Phase 2 Remedial Investigation Work Plan Addendum No. 8,
Former Grumman Settling Ponds (Operable Unit 3, - Bethpage Community Park),
Bethpage, New York.

Date:
December 20, 2006

Table 2. Summary of Proposed Additional Soil Gas, Ambient Air, and Groundwater Samples, Work Plan Addendum No. 8, Former Grumman Settling Ponds (Operable Unit 3 - Bethpage Community Park), Bethpage, New York.

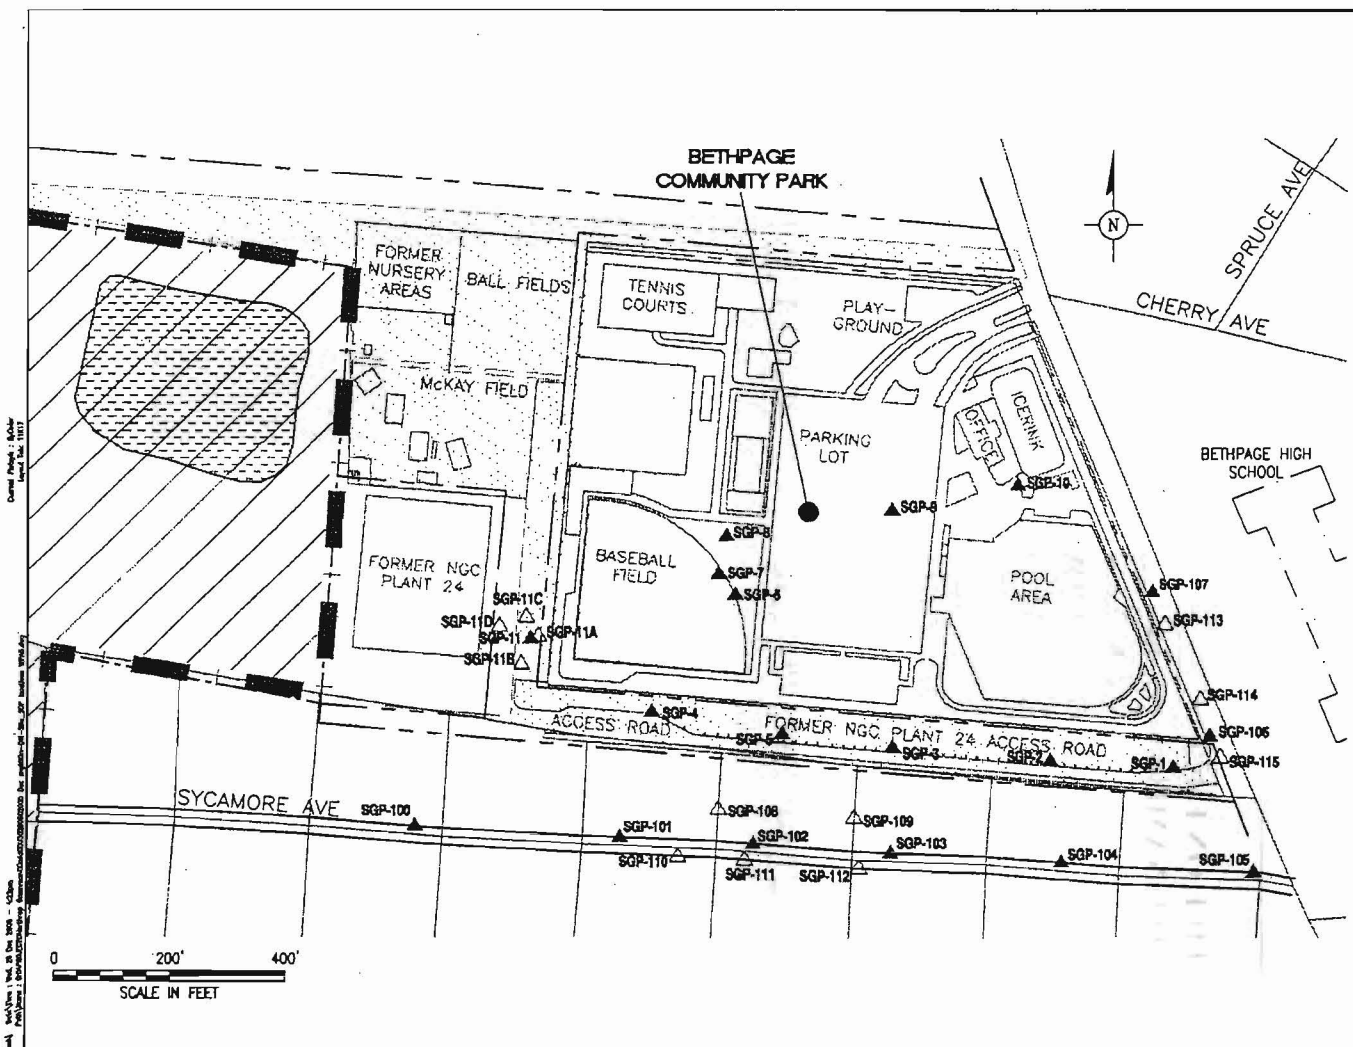
In addition to the on-site ambient air study, ARCADIS proposes to collect off-site soil gas samples. As shown on Figure 1 and described on Table 2, a total of eight soil gas point locations are proposed on the Town rights of way, along Sycamore Avenue and Stewart Avenue (identified as SGP-108 to SGP-115). Four soil gas point locations are also proposed in an area southwest of the Park, on NGC property (identified as SGP-11A to SGP-11D). The proposed soil gas samples will serve to develop information as to the various VOC transport mechanisms in soil gas (see above), refine the CSM, and verify the previously detected VOC soil gas concentrations in areas where TCE was detected above the NYSDOH Air Guideline Value. Overall, ARCADIS proposes to collect a total of 32 soil gas samples from up to three different depths at each location (i.e., 8 ft bls, 20 ft bls, 50 ft bls) (see Table

1. AN AMBIENT AIR STUDY TO BE PERFORMED ON A INDEPENDENT SCHEDULE. AMBIENT AIR SAMPLE LOCATIONS TO BE DETERMINED.
2. SGP-100 TO SGP-105 COMPLETED ON NORTH SIDE OF SYCAMORE AVE. PROPOSED SGP-110; SGP-111; AND SGP-112 WILL BE COMPLETED ON SOUTH SIDE OF SYCAMORE AVE. ALL LOCATIONS SUBJECT TO FIELD VERIFICATION.
3. ALL SGP LOCATIONS PROPOSED FOR AREAS TO THE SOUTH AND EAST OF BETHPAGE COMMUNITY PARK WILL BE DRILLED ON TOWN OF OYSTER BAY RIGHTS-OF-WAY.
4. ALL SGP LOCATIONS WILL BE PROPERLY ABANDONED AFTER COMPLETION OF SAMPLING.
